# UNITED STATES PATENT AND TRADEMARK OFFICE

10/687,811

**Office Action Summary**

**DETAILED ACTION**

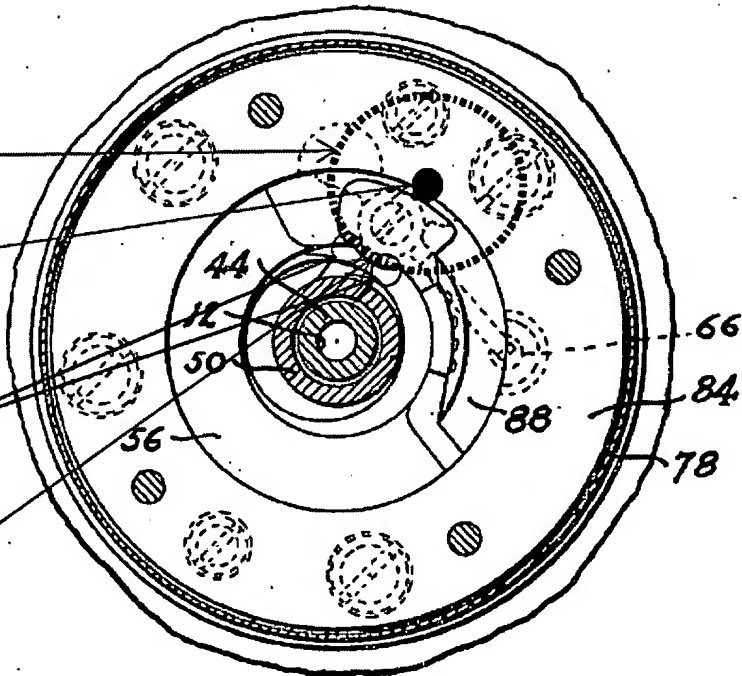
Examiner Comment #1 -  
Enclosed Container  
within housing  
hermetically sealed  
compressor ( element 32)

Examiner Comment #2 -  
Upper end portion of shaft  
(element 48) within  
enclosure of comment #1

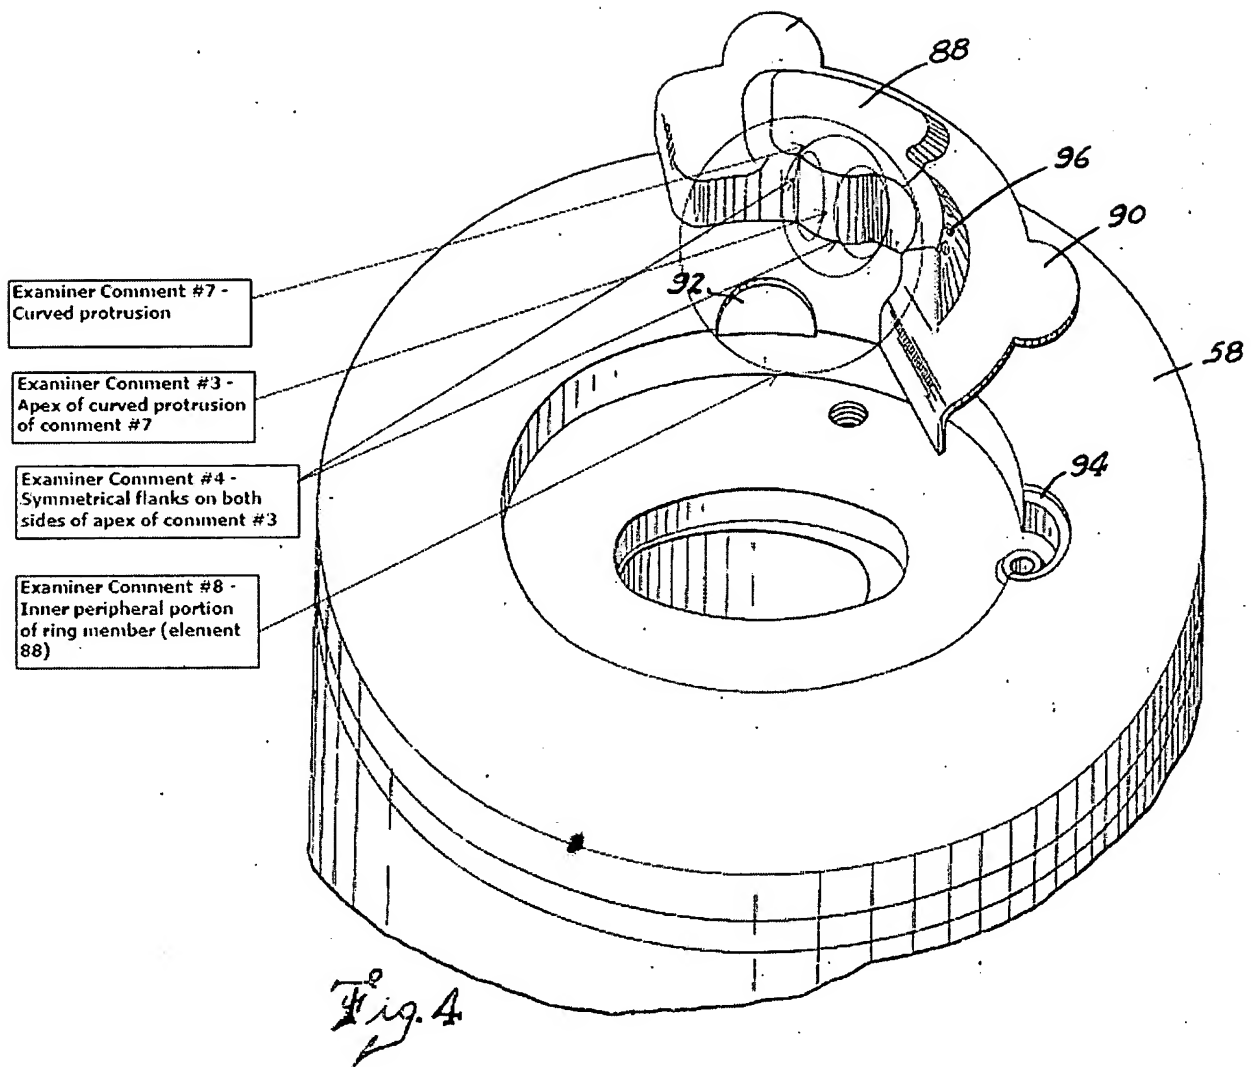
Examiner Comment #5 -  
Radius of curvature  
of flanks of comment #4

Examiner Comment #6 -  
Center of radius of  
curvature of comment #5

Examiner Comment #4 -  
Symmetrical flanks on both  
sides of apex of comment #3

Examiner Comment #3 -  
Apex of curved protrusion  
of comment #7
